ADDENDUM 4

Date Issued January 30, 2026

Project Name | Job # White Earth Withdrawal Management Facility 20237410

THIS ADDENDUM AMENDS AND BECOMES PART OF THE CONTRACT DOCUMENTS FOR EAPC PROJECT 20245580 DATED 12/5/2025, RESPECTIVELY. EACH BIDDER SHALL ACKNOWLEDGE RECEIPT OF THIS ADDENDUM BY MARKING THE ADDENDUM NUMBER AND DATE ON THE BID FORM.

A101

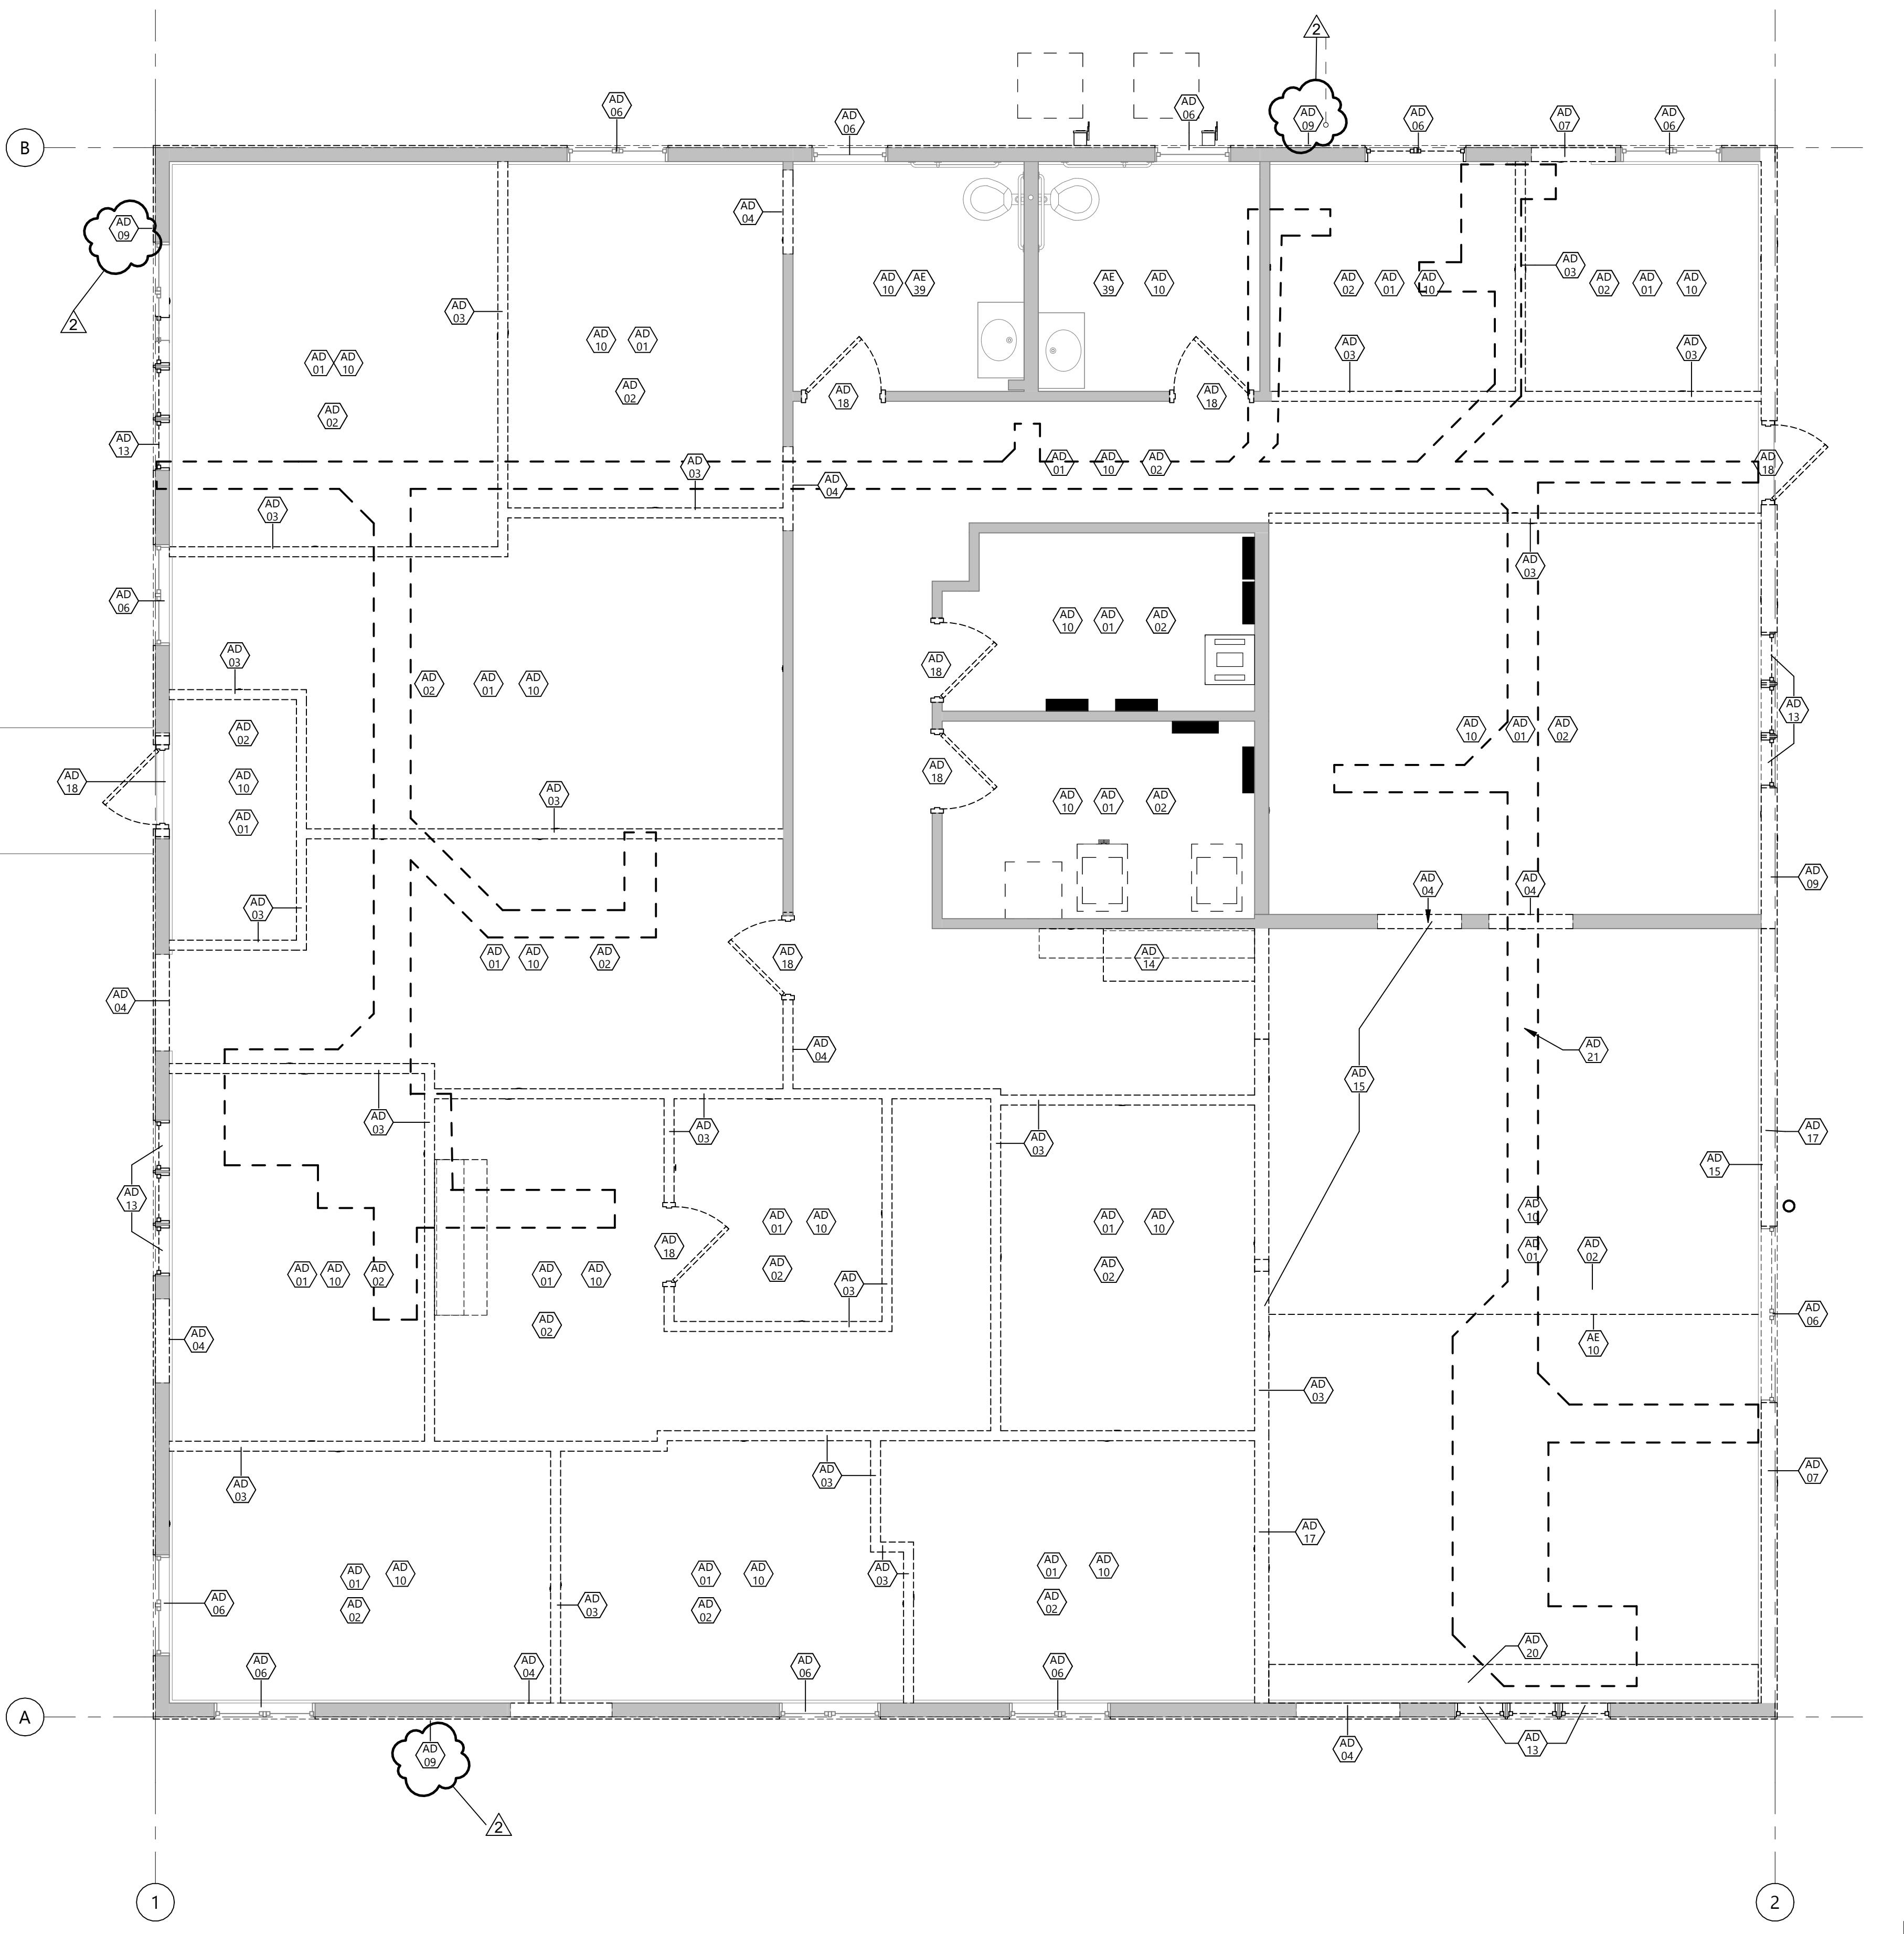
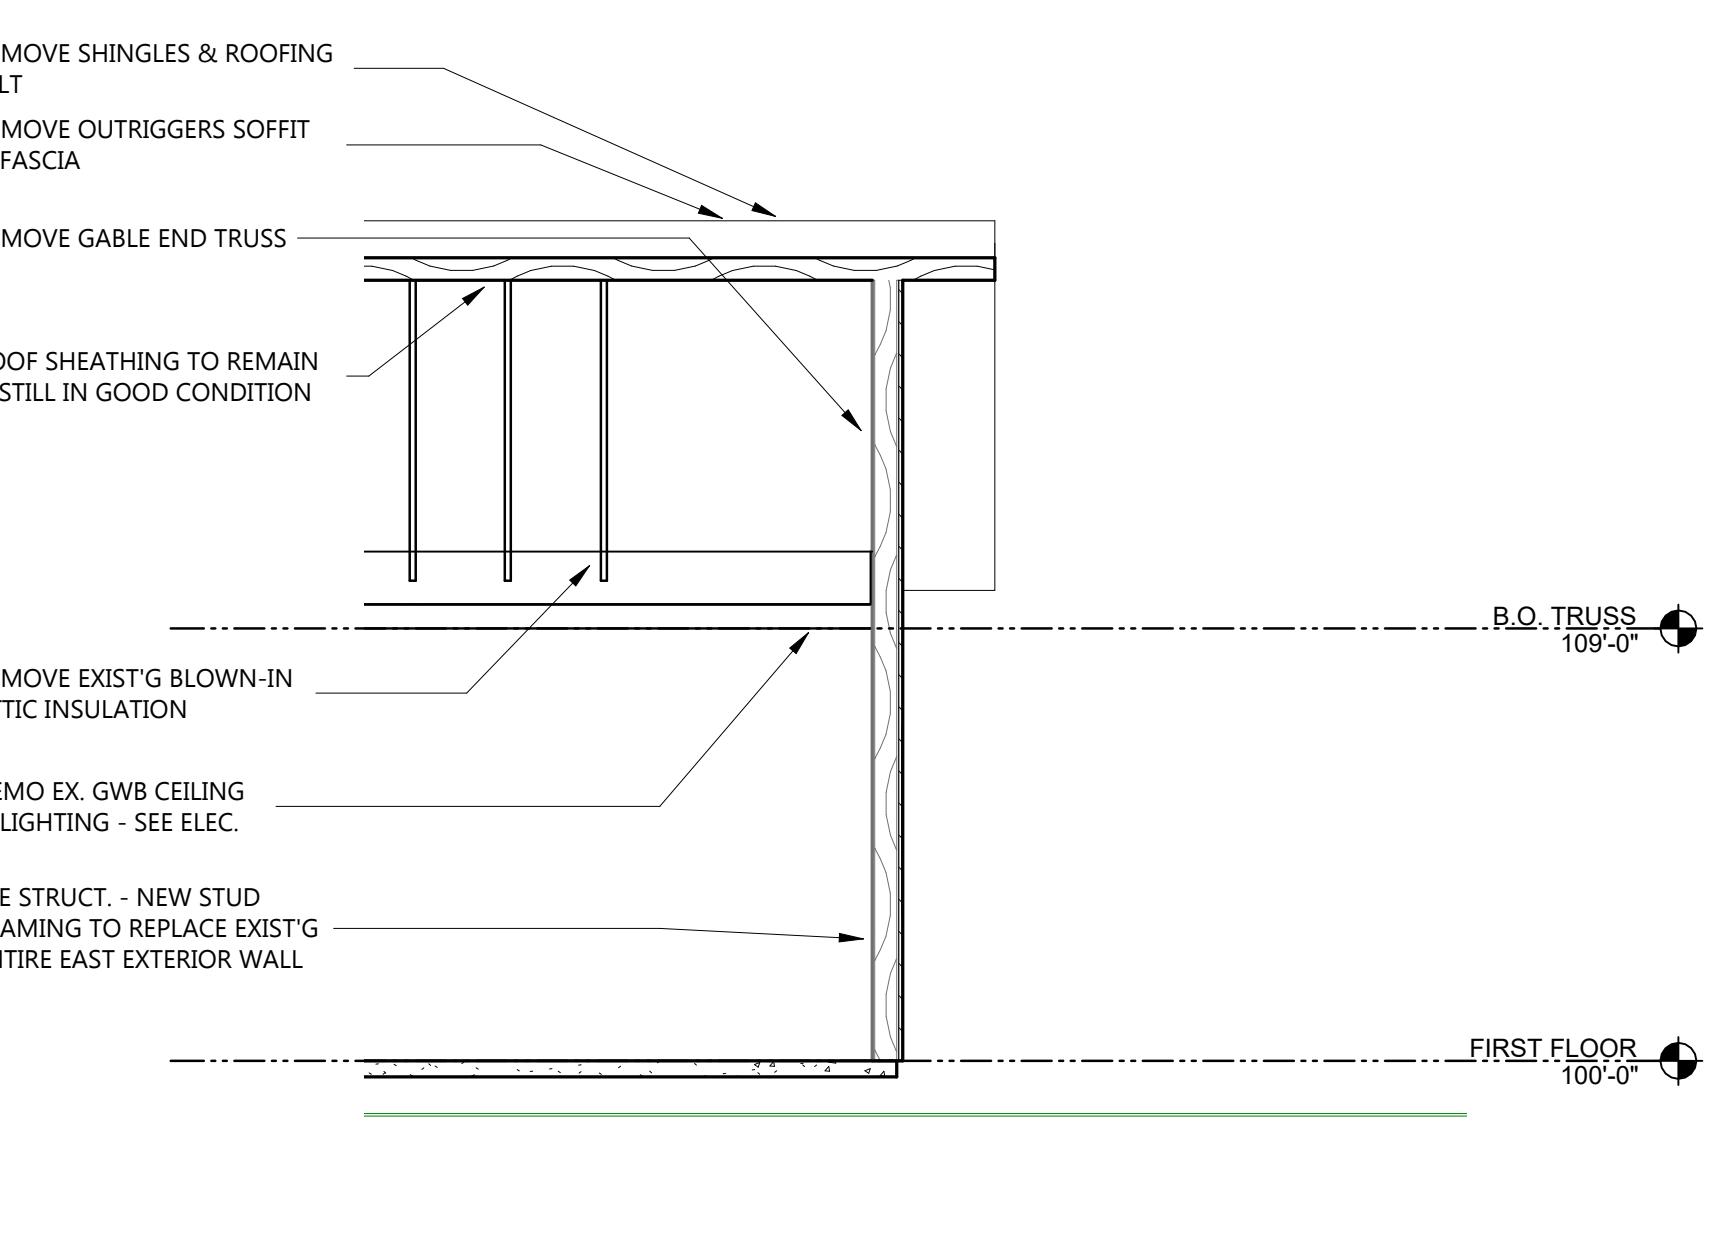
A101	Modify demo note AD08 to read AD09.
A301	Add ceiling access panel to room 117. See attached A301.
A801	Modify doors 116, 117, 118 .1, 119, 120, 121, 122, 123, 123A, 133, 130, 134.1, 134.3 to be 20 min fire rated. See attached A801.
P101	Change demo items to include all propane equipment
P202	Changed propane piping and related equipment to natural gas piping and equipment
P801	Changed water heater fuel from propane to natural gas
M801	Changed furnace fuel from propane to natural gas

DRAWING TITLE
**DOOR SCHEDULE,
DOOR AND WINDOW
ELEVATIONS DETAILS**
A801

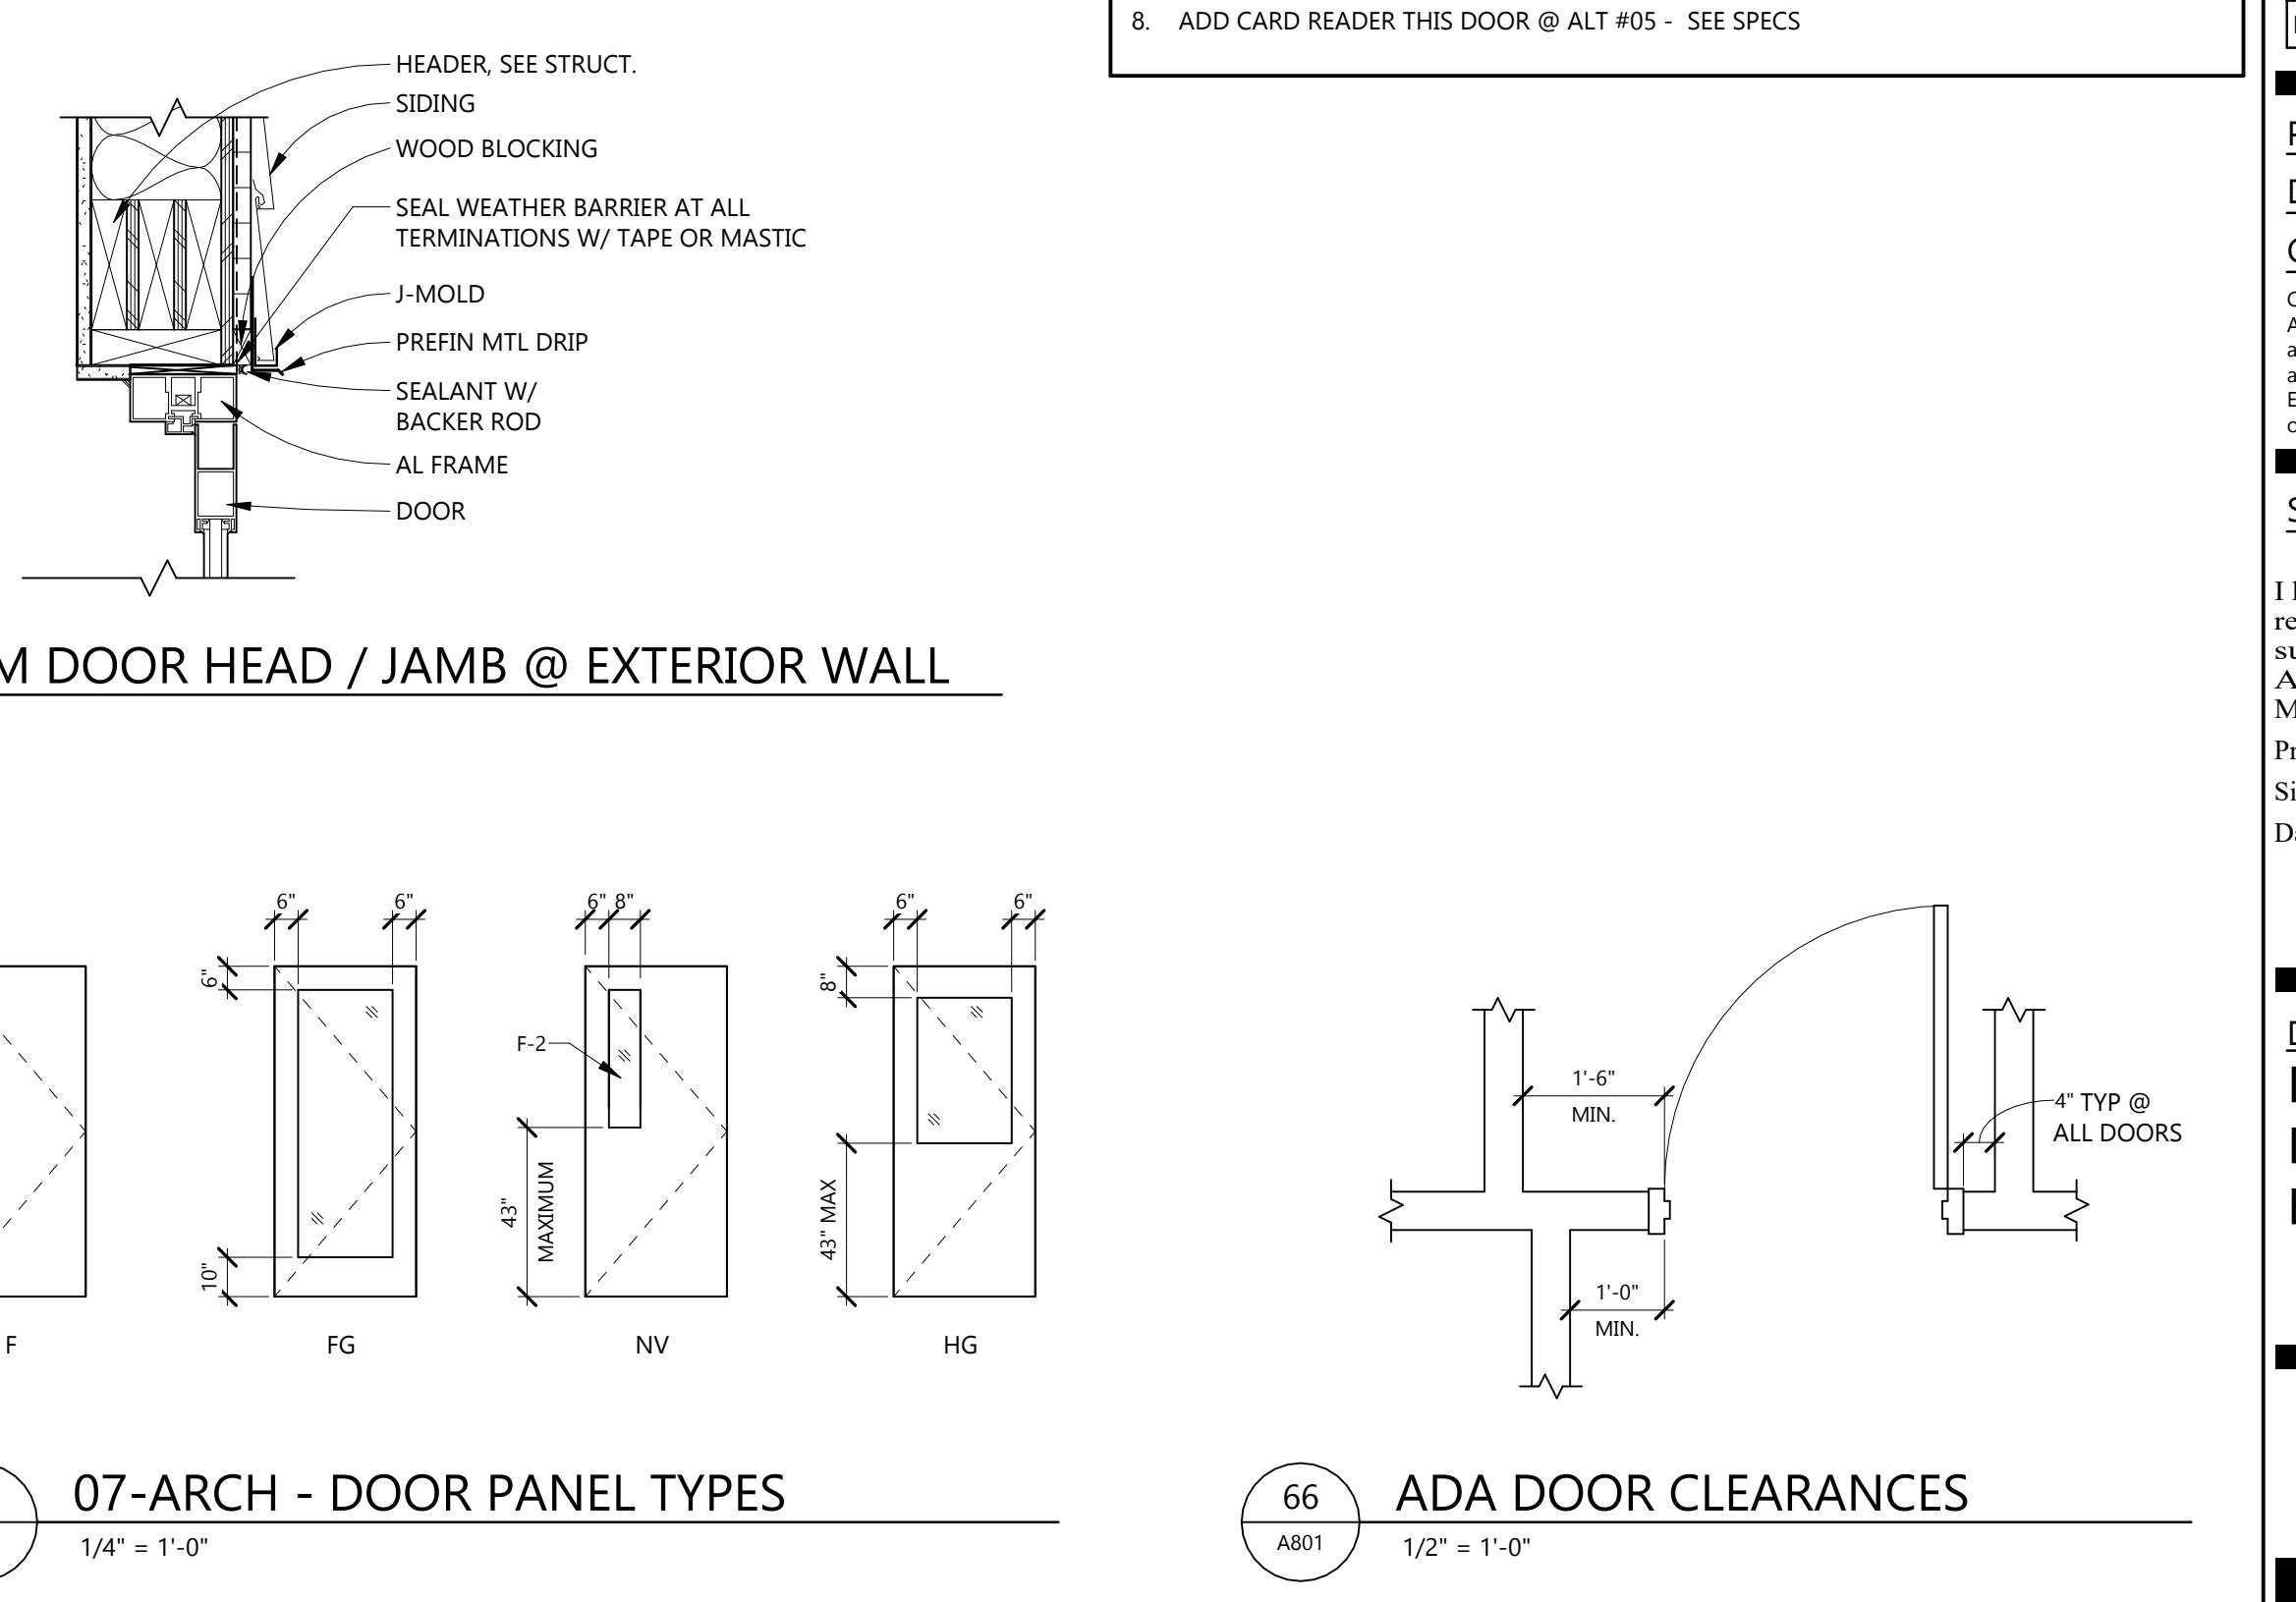
Doors showing card reader access with Door Note 3. on door schedule to be base bid. Doors 103, 109, 113.2, 118.1, 120, 121, 123, & 123A receiving Door Note 8. to be Add. Alt #05.
